Product Change Notification (PCN)

PCN Number: PCN_UtLAN_20260714 Affected Series: WE-LAN Affected Part Number: 749020112B PCN Date: 2026-04-14 (YYYY-MM-DD) Effective Date: 2026-07-14 (YYYY-MM-DD)	Change Category: ☐ Equipment/Location ☐ General Data ☐ Material ☐ Process ☒ Product Design ☐ Shipping/Packaging ☐ Supplier ☐ Software
Contact: Product Management Phone: +49 (0) 7942 - 945 5001 Fax: +49 (0) 7942 - 945 5179 E-Mail: pcn.eisos@we-online.com	Datasheet Change: ☒ Yes ☐ No Attachment: ☐ Yes ☒ No

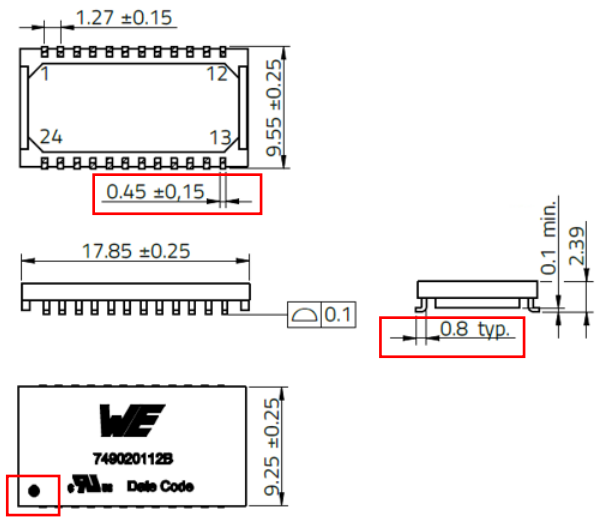
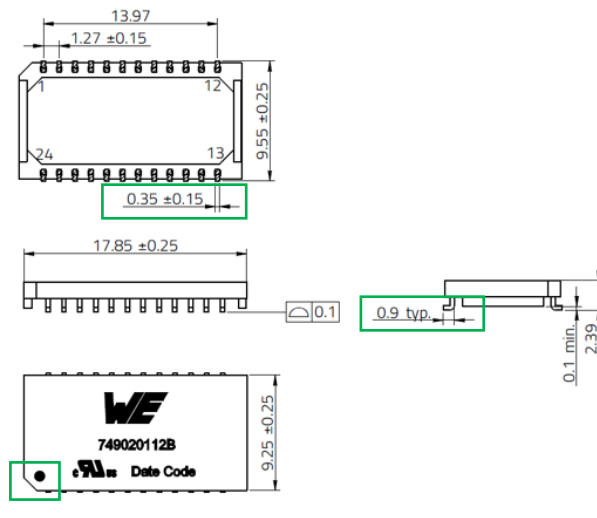
Due to an improvement of the production capability, Würth Elektronik eiSos will develop a new housing to facility manufacturing, therefore the housing and core will be changed slightly.

- Housing change:**

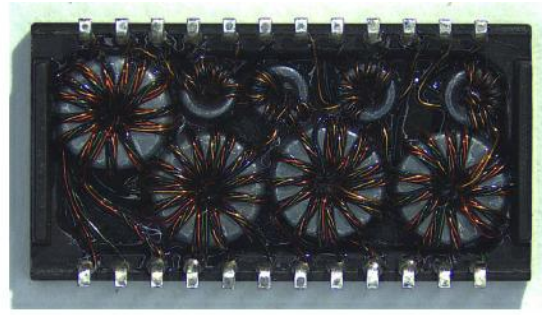
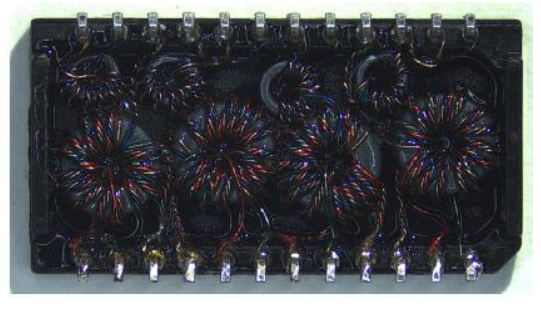
Before Change	After Change
